ADDENDUM NO. 1

**ARCADIA HIGH SCHOOL
LOCKER ROOM ALTERATION
ARCADIA UNIFIED SCHOOL DISTRICT**

tBP/ARCHITECTURE
4611 Teller Avenue
Newport Beach, CA 92660
949-673-0300

This Addendum forms a part of the Contract Documents and modifies the original Bidding Drawings dated August 15, 2024, and Specifications dated July 2024. Acknowledge receipt of this Addendum in space provided on the Bid Form. Failure to acknowledge may subject Bidder to disqualification.

drawing title:
MECHANICAL BLDG. GL
- FLOOR PLANS

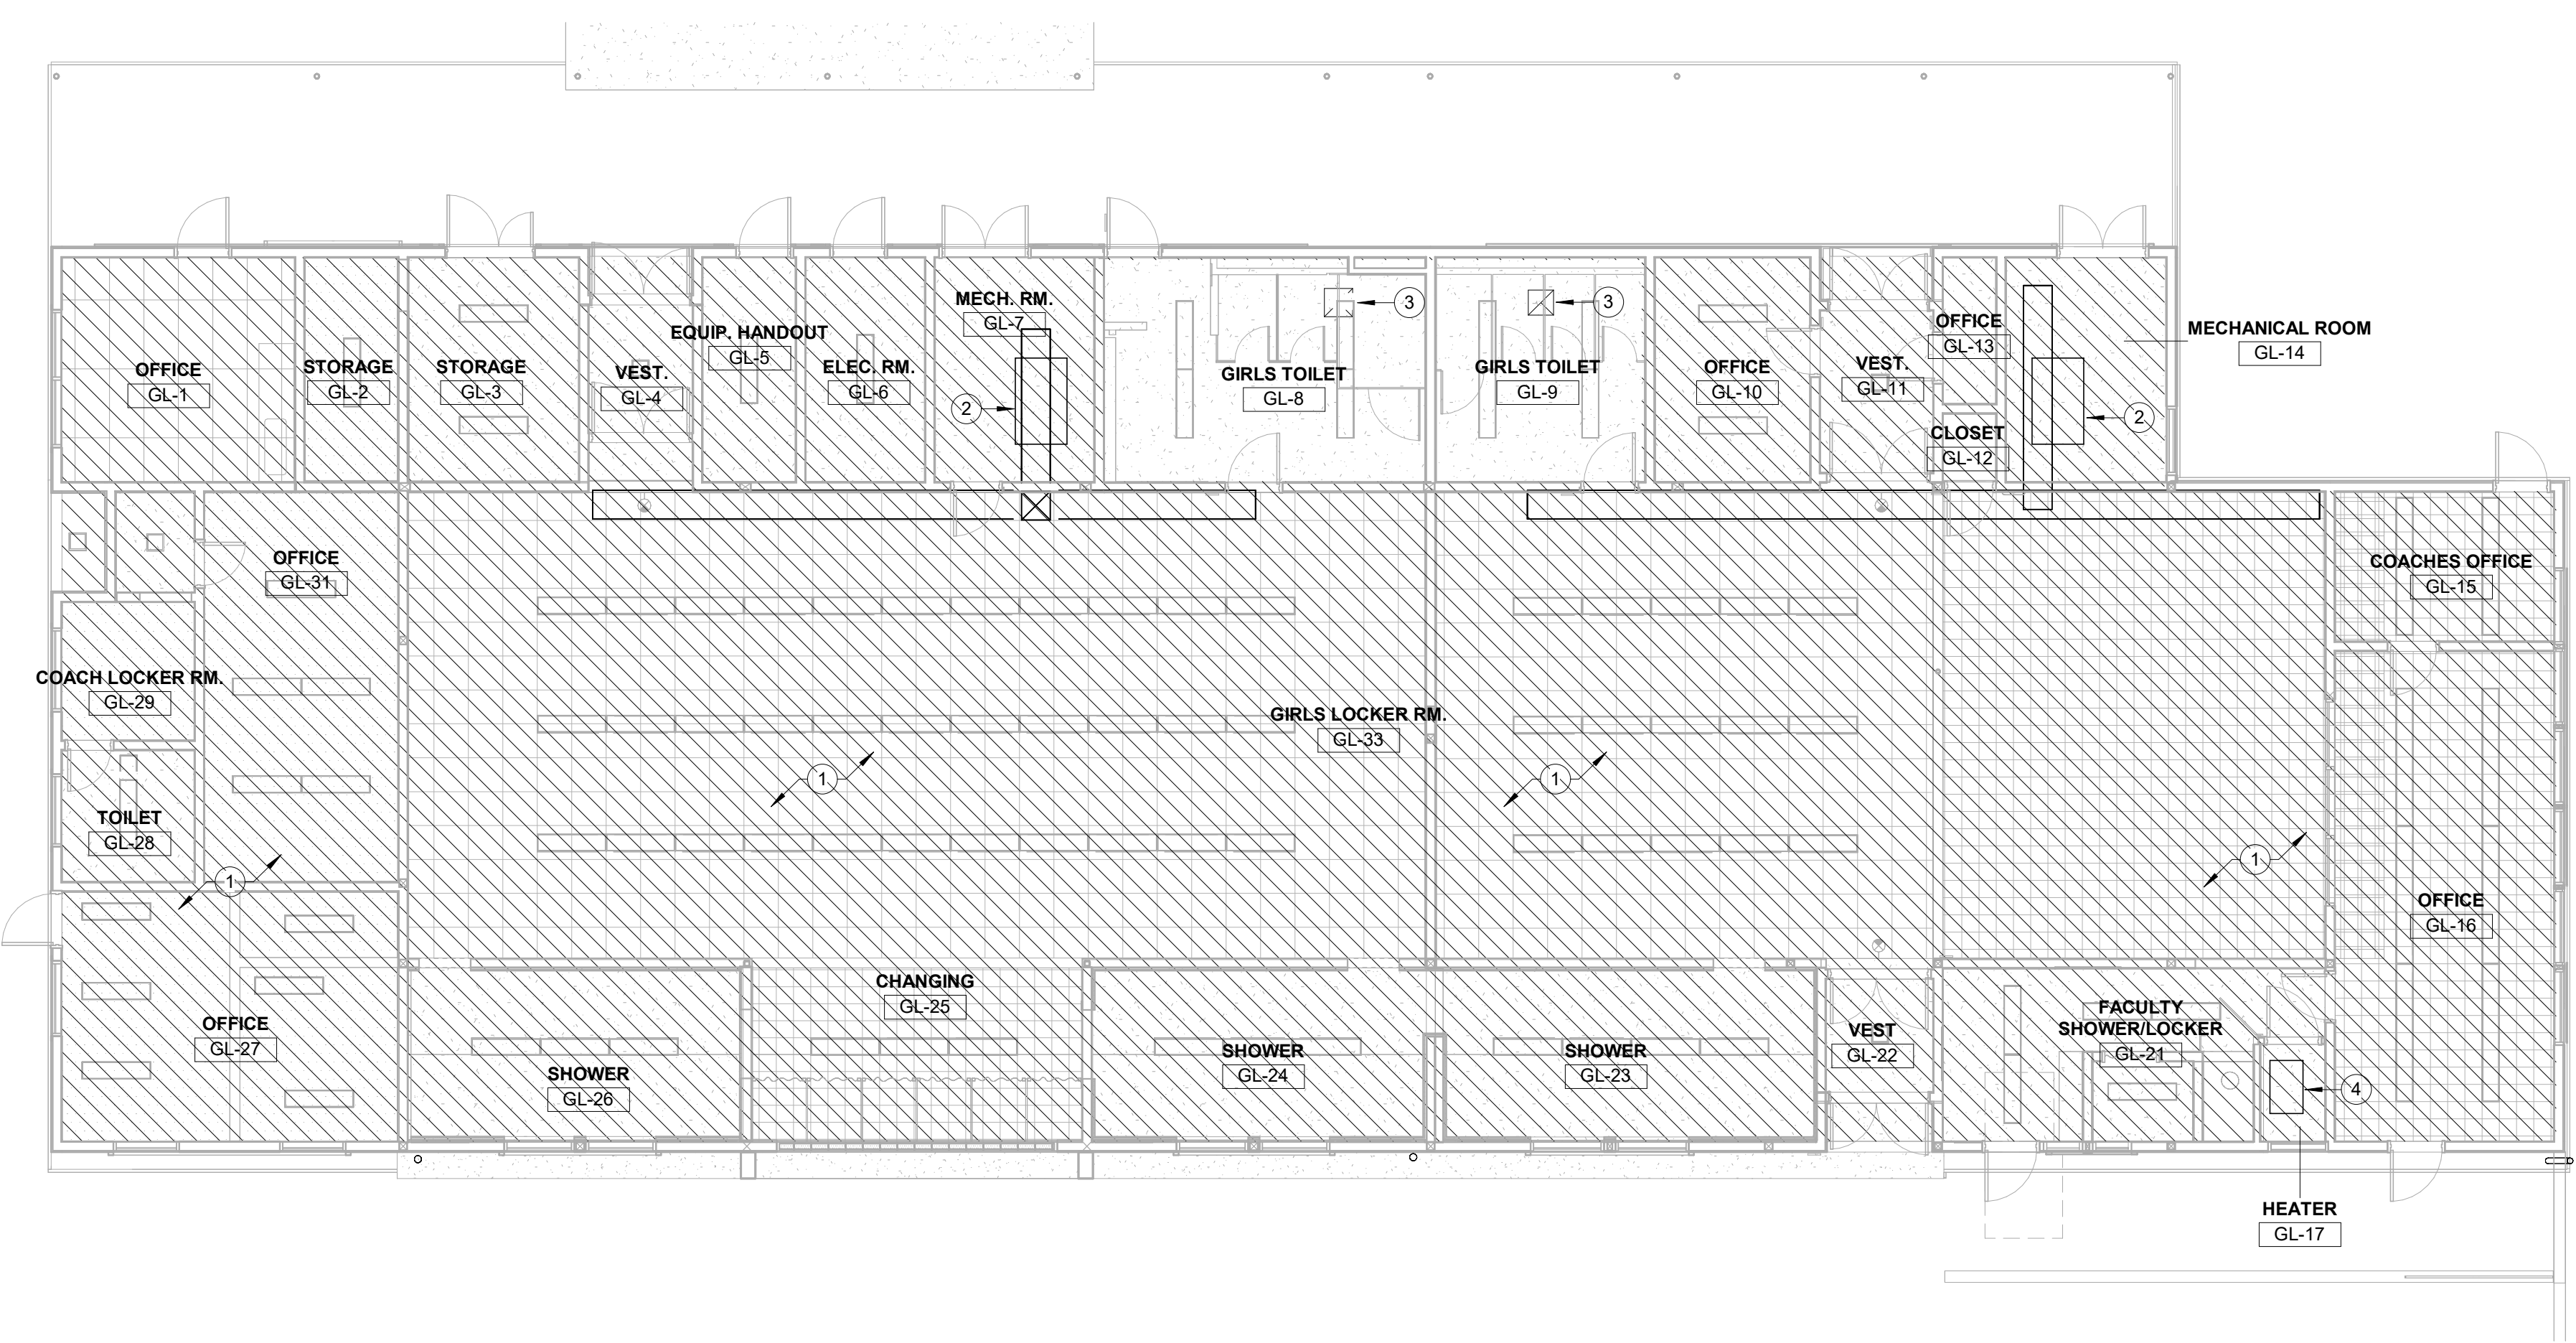
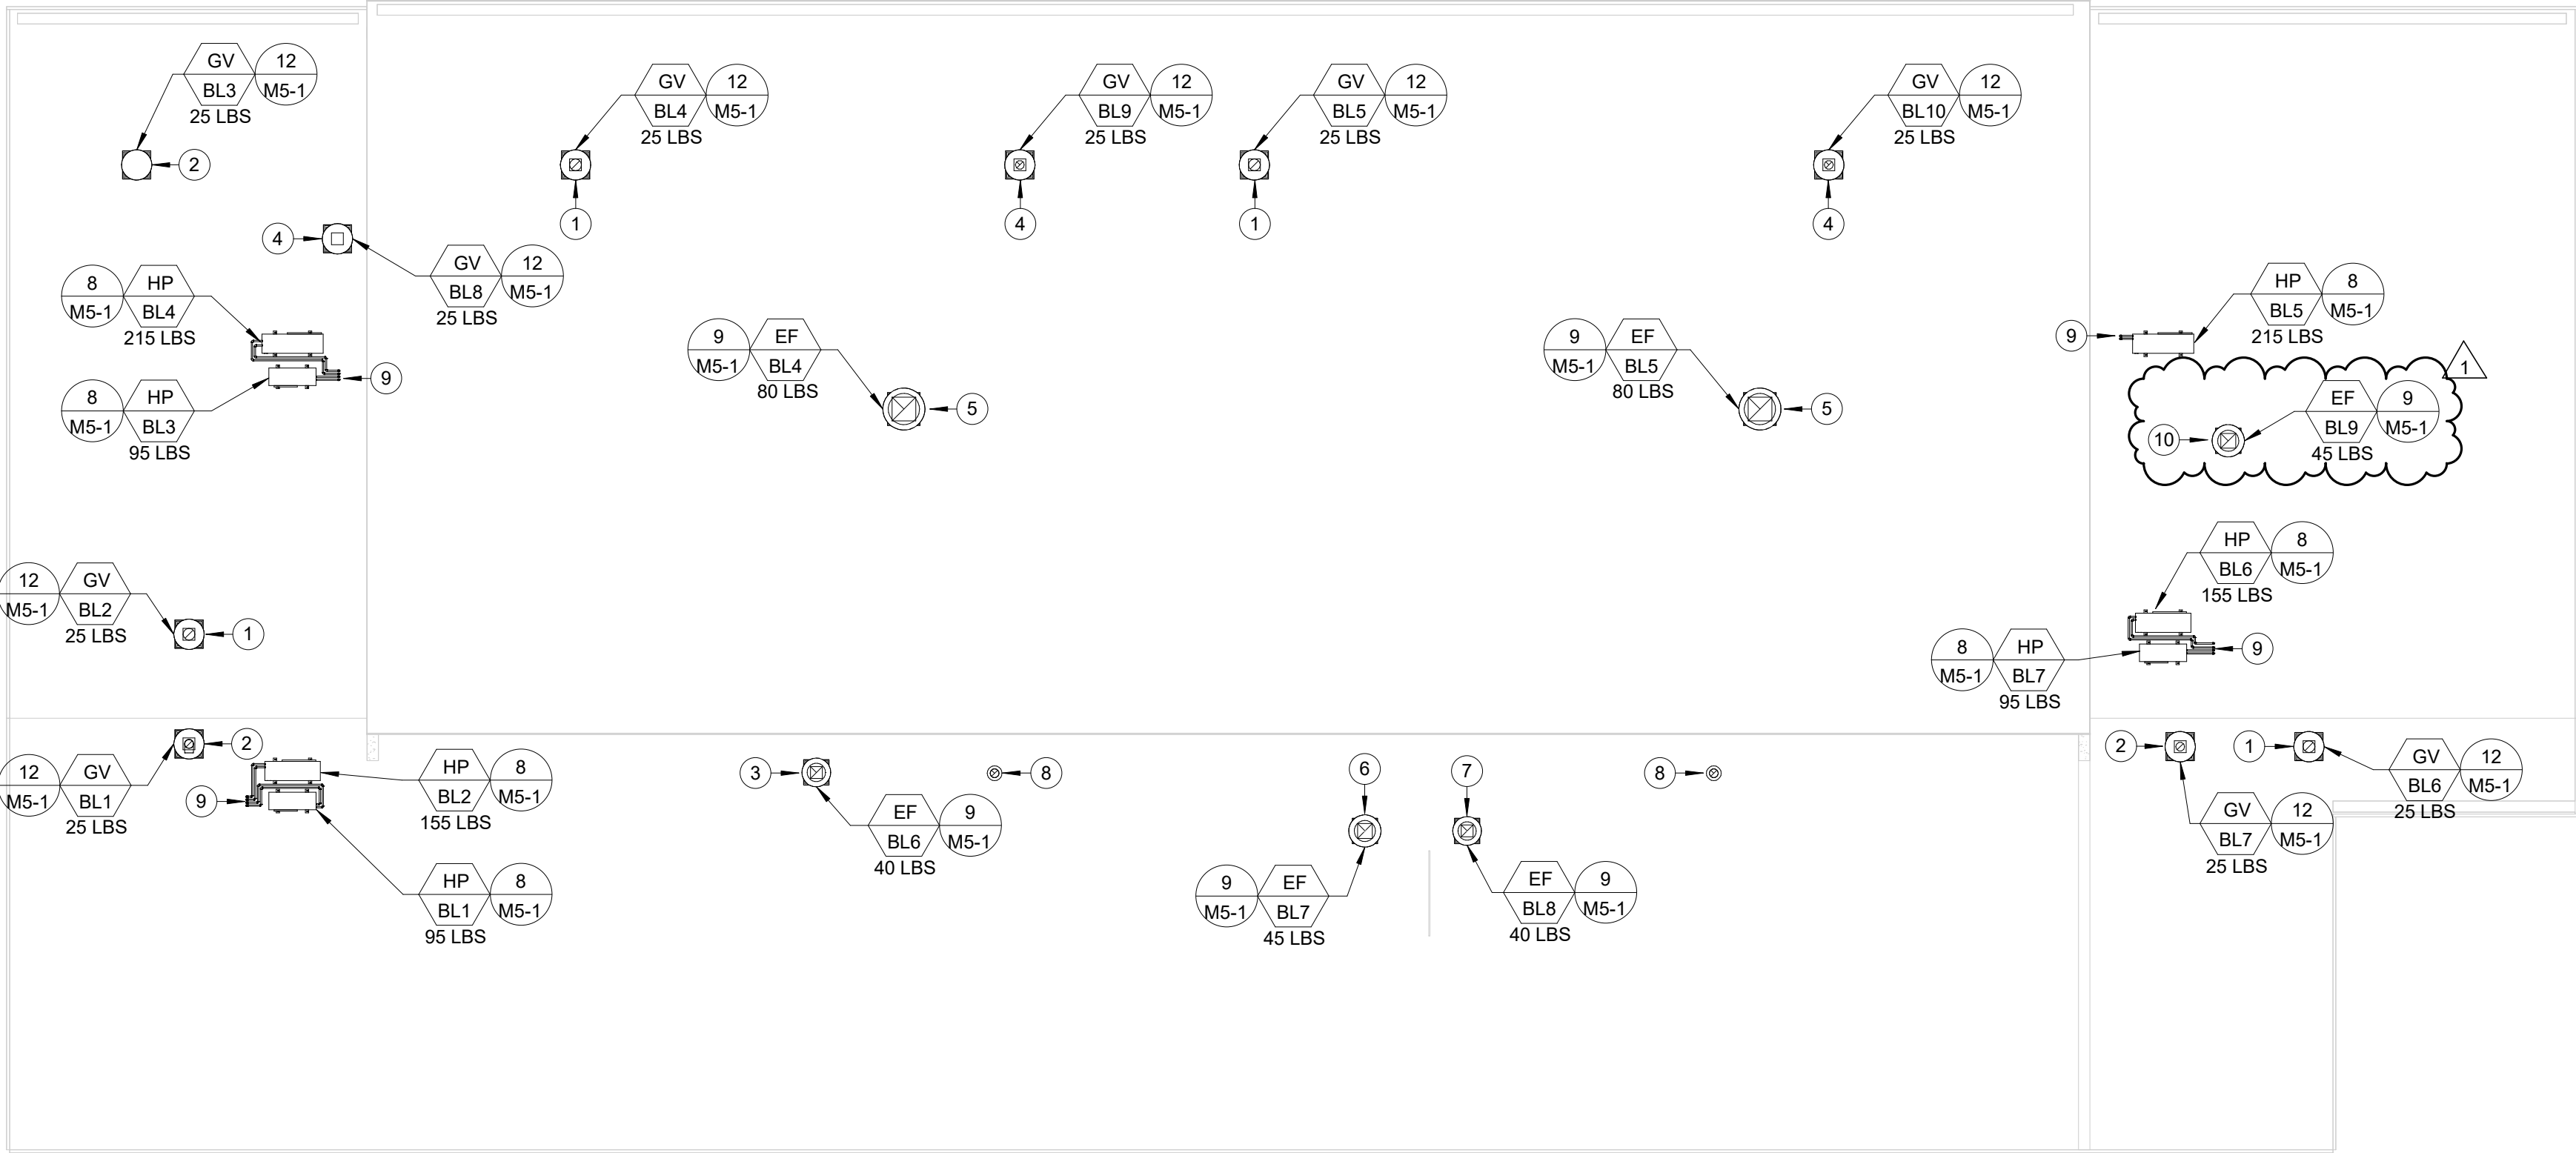
- b. Relocate mechanical registers in Offices in accordance with architectural plan.
 - c. Add louver to existing door at All Gender Restroom, BL-9.
- 22. SHEET M2-2 – MECHANICAL BUILDING GL – FLOOR PLANS
Replace full size sheet drawing **M2-2** in its entirety, issued with this addendum.
Changes include:

- a. Relocate air ducts and associated register above showers.
 - b. Relocate mechanical registers in Offices in accordance with architectural plan.
- 23. SHEET M4-1 – MECHANICAL BUILDING BL – ROOF PLANS
Replace full size sheet drawing **M4-1** in its entirety, issued with this addendum.
Changes include:
